RE: **Heritage Marketplace Tract A2 (Burger King)**
7900 Ladera Dr NW
Grading and Drainage Plan
Engineer's Stamp Date 12/27/17 (File: H09D024A)

Based on the information provided in your submittal received 12/27/17, the Grading and Drainage Plan is approved for Site Plan Building Permit with the condition that written permission from the adjoining property owner (Walmart) for work on their property be received prior to DRB approval of the Site Plan.

RE: **Heritage Marketplace Tract A2 (Burger King)**
7900 Ladera Dr NW
Grading and Drainage Plan
Engineer's Stamp Date 12/19/17 (File: H09D024A)

Richard Dourte P.E. #10854	Title: BURGER KING 7900 LADERA DRIVE NW GRADING AND DRAINAGE PLAN	DRAWN BY
		DATE
	RHD Engineering, LLC 4305 Purple Sage Ave. NW ALBUQUERQUE, NM 87120 (505) 288-1621	SHEET # 1 of 2
		JOB #

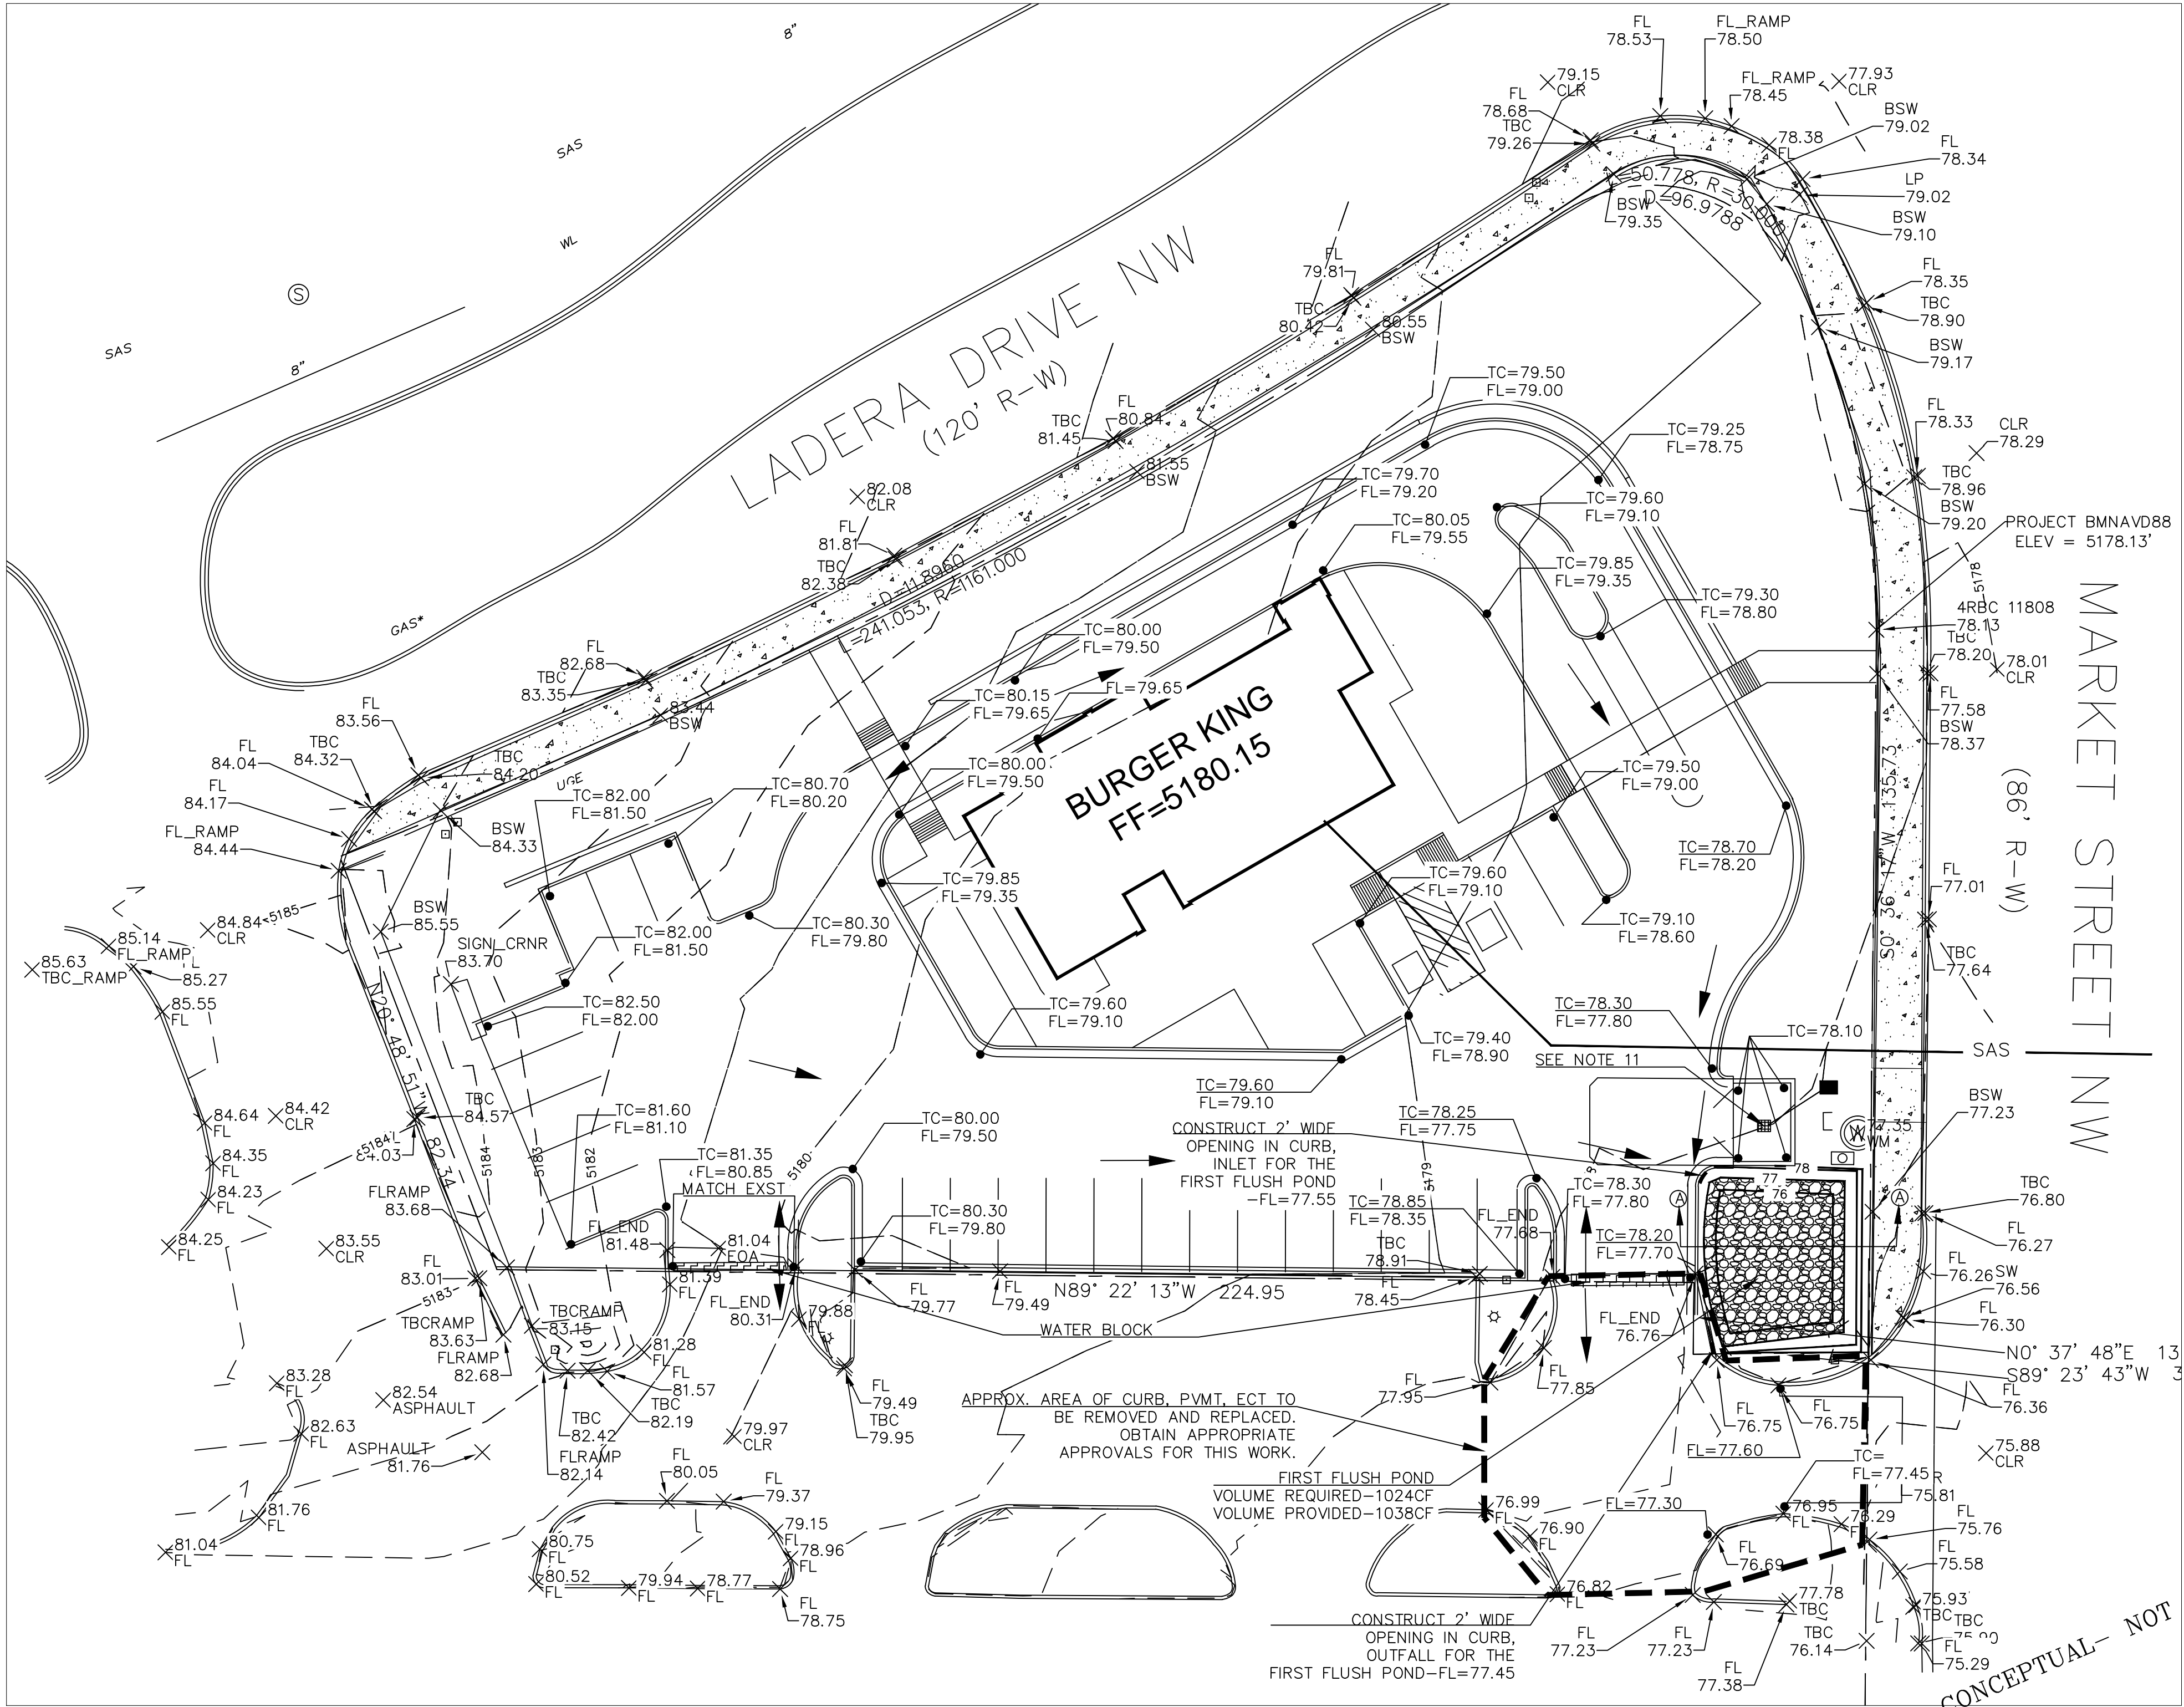
1. The Grading and Drainage Plan will need to be clearly labeled as "Conceptual, not for construction" for inclusion in the Site Plan.
2. Include a narrative describing how this plan of development is in compliance with the approved Heritage Marketplace Drainage Report (H09D024).
3. The dumpster area should be contained, plumbed through a grease trap, and into the sanitary sewer. Include the utility plan if this information is located there. You may also want to raise the dumpster pad elevation to keep storm water from entering the dumpster area.
4. Please provide written permission from the adjoining property (Walmart) for work on their property.

5. A detailed grading and drainage plan, with the "conceptual" markings removed will be required for Building Permit.
6. It is unclear that storm water will be forced into the pond at the curb cut. Please include a clearly defined waterblock at the SE property line/drive entrance that will force flows into the pond instead of allowing them into the Walmart parking lot.

1. I incorporated these changes into the drainage plan. (for site plan approval)
2. The drainage narrative note no. 2 has been expanded on to help clarify how this site conforms with the overall master drainage plan for this area.
3. I incorporated these changes into the drainage plan.
4. This is presently being worked on.
5. This will be done when after the "conceptual drainage plan" has been approved.
6. I incorporated these changes into the drainage plan.
7. This item will need to be provided with the 'drainage plan for building permit'.
8. Thank you for the information.
9. The Private Facility Drainage Covenant will be provided for C.O.
10. Thank you for the information.

1. THIS SITE IS NOT LOCATED WITHIN A FLOOD PLAIN. REFER TO THE FEMA EXCERPT THIS SHEET.
2. THIS SITE IS LOCATED WITHIN A MASTER PLAN DRAINAGE AREA. IT IS IDENTIFIED AS BASIN A4 WITHIN THE HERITAGE MARKET PLACE MASTER PLAN(H09-D024). BASIN A4 (PER THE AHYMO OUTPUT PAGE 5) ALLOTS 3.84 CFS FOR THIS PROPERTY (100YR, 6HR). THIS SITE GENERATES 3.58CF (100YR, 6HR) AS SHOWN ON SHEET 2. THUS THIS SITE COMPLIES WITH THE MASTER DRAINAGE PLAN.
3. THE REQUIRED FIRST FLUSH RETENTION IS 965CF. THE FIRST FLUSH POND VOLUME IS 1038CF, THUS ADEQUATE VOLUME IS RETAINED.
